## TECHNICAL BULLETIN

[Issue No.] FA-A-0145-B [Title] Change in the 40-pin connectors of MELSEC-Q series modules [Date of Issue] October 2012 (Ver. B: July 2016) [Relevant Models] QY42P, QH42P, QX41Y41P, QX42, QX42-S1

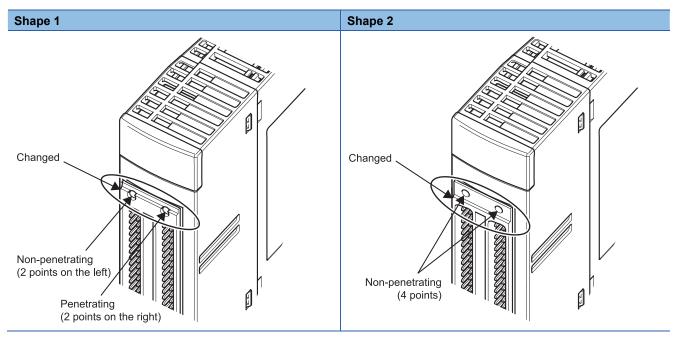
The 40-pin connectors of the above relevant models are changed. There is no impact on the general specifications, performance specifications, and functions of modules due

The shape of the adjacent area of connector fixing screws is changed from "Shape 1" to "Shape 2". The change for the relevant models will applied in the changeover period described in Section 3.1.

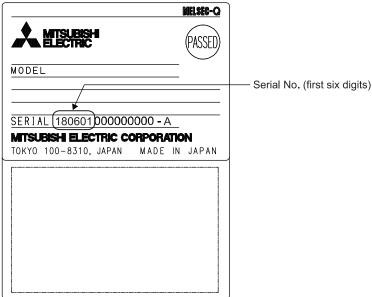
Check the serial number (first six digits) in the SERIAL field on the rating plate located on the side of the module.
